Re: Proposed Townhomes at Woodbank 0 Warburton Avenue

As the Architect representing PTG Development, LLC, owner of 0 Warburton Avenue, I am submitting the attached revised drawings, dated May 4, 2017, describing six new townhouses at 0 Warburton Avenue, for site plan, view preservation, and steep slopes review. Our submission consists of the following drawings:

In response to comments made by the Planning Board at the meeting on March 16, 2017, the drawings were revised, and additional drawings were prepared, as follows:

S-1

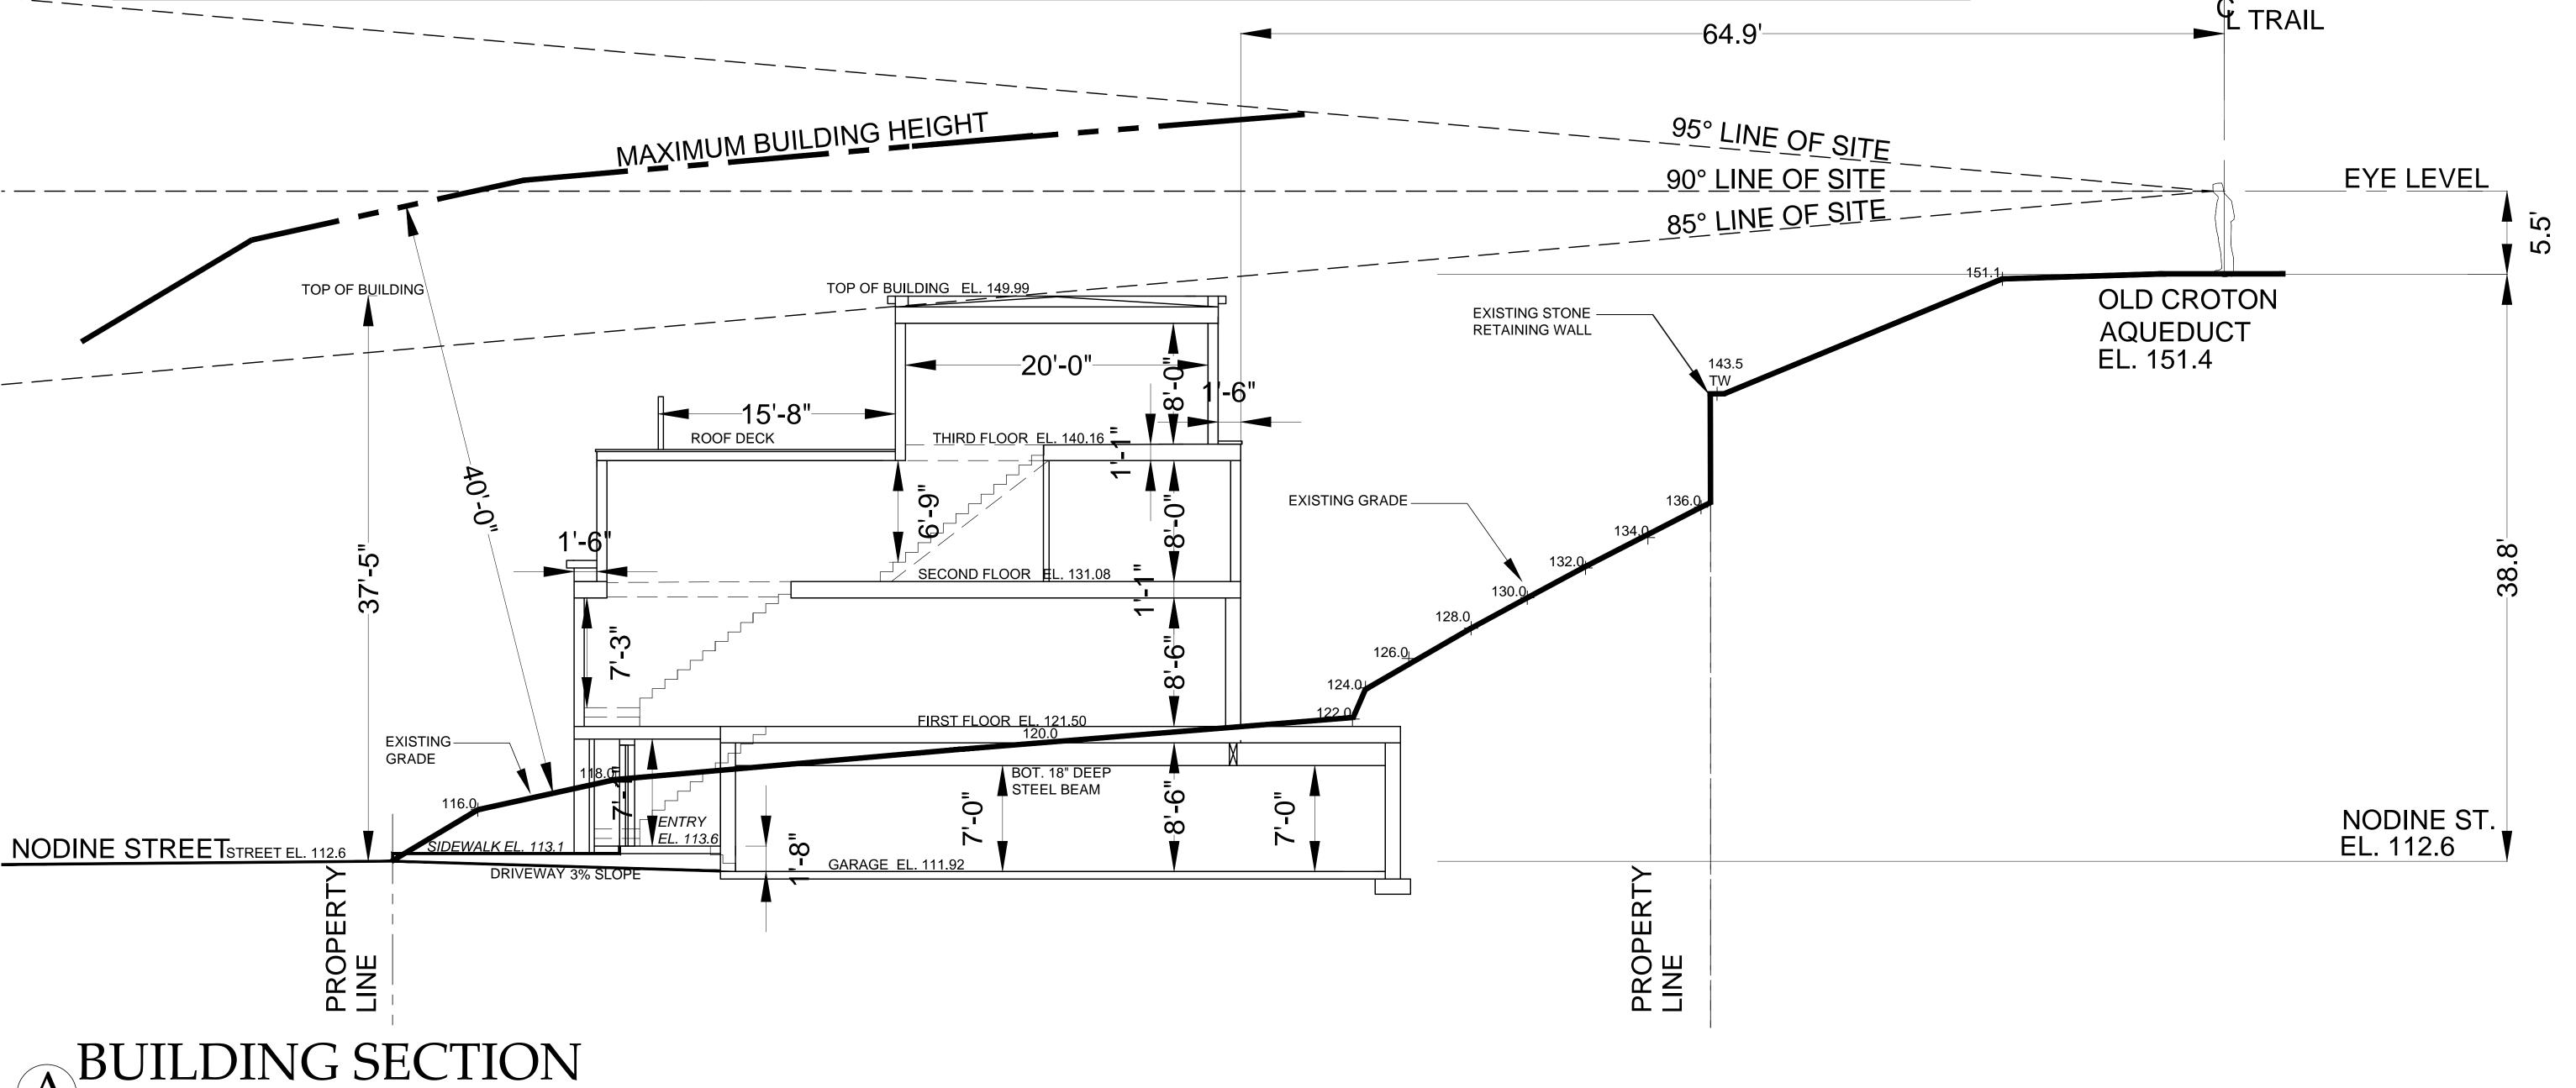
1. The Old Croton Aqueduct (OCA) and neighboring properties were surveyed to provide elevations of the OCA trailway, Nodine Street, and heights of surrounding buildings. These elevations are shown on the revised survey and the site plan and site sections, see Drawings S-1, S-2, S-5, S-6 & S-7.

S-1B

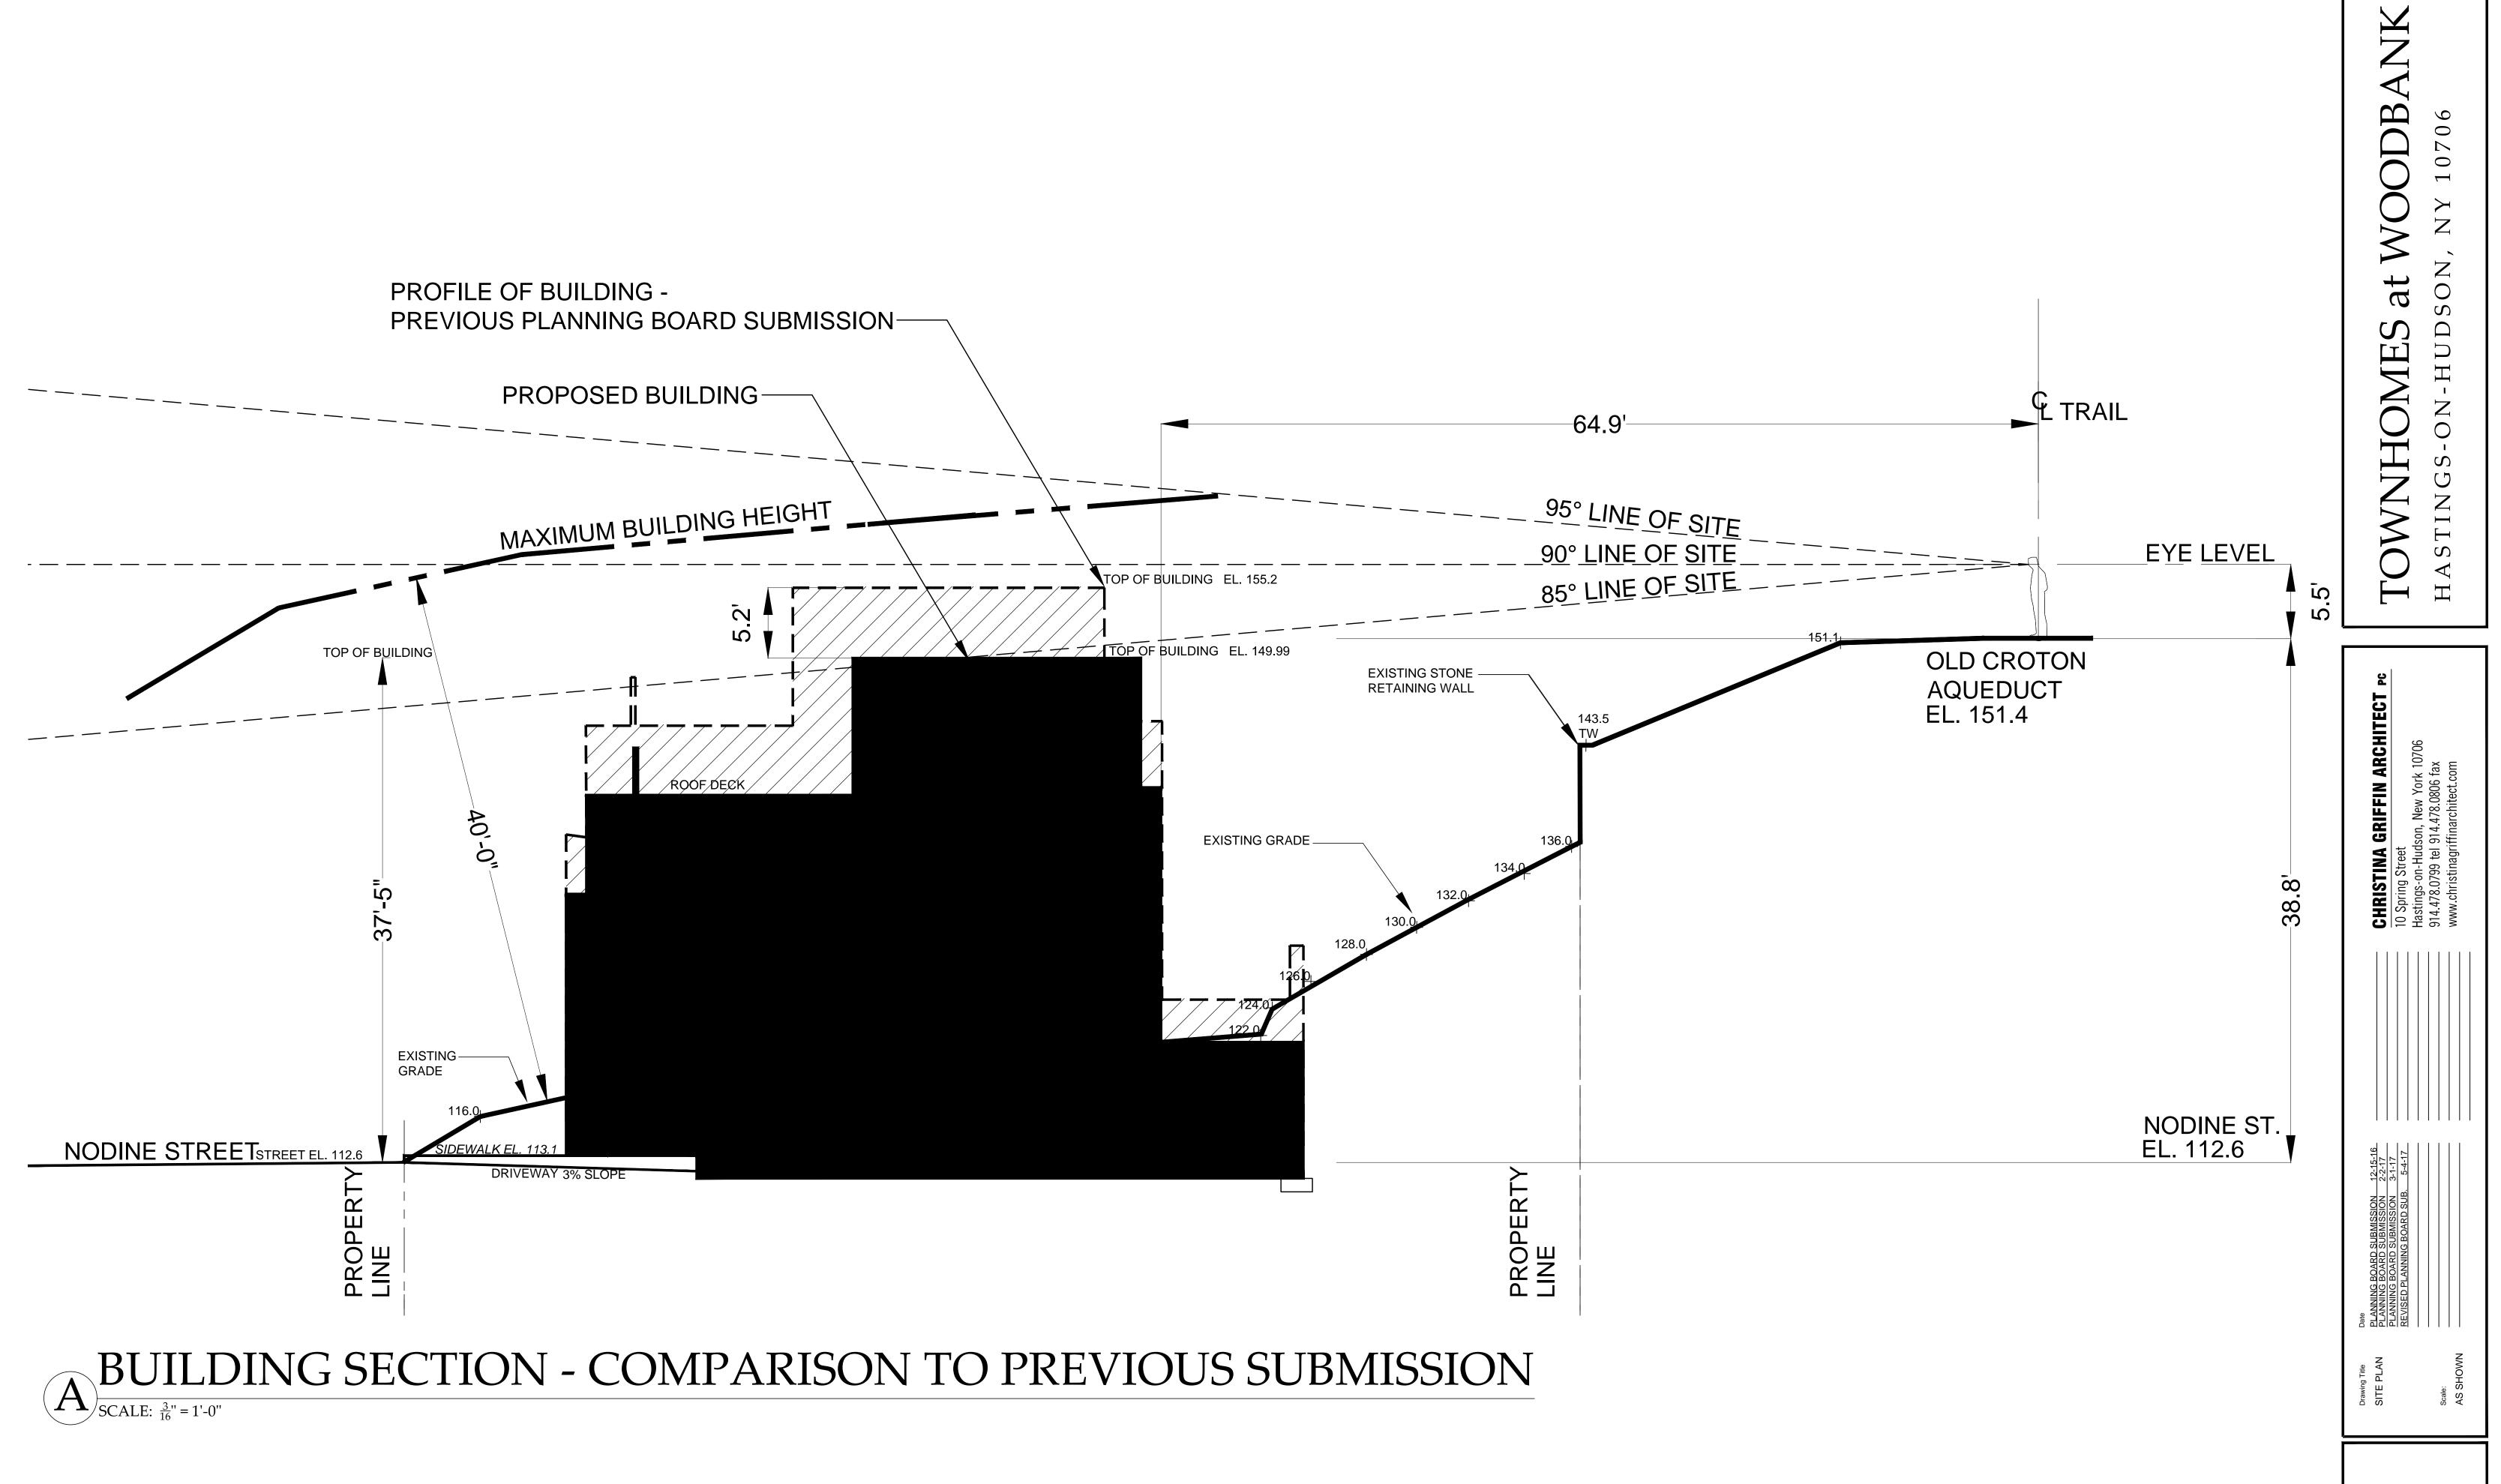
- 3. The total open space area has increased to 9,294 SF from 7,836 SF.
- 4. The proposed building is 5.2 feet lower than the previously submitted building, due to the newly established street elevation of 112.6 and due to the lowering of the ceiling heights at the garage, first floor and second floor. See revised elevations A-4 – A-7, and revised view studies VP-1 – VP-12.
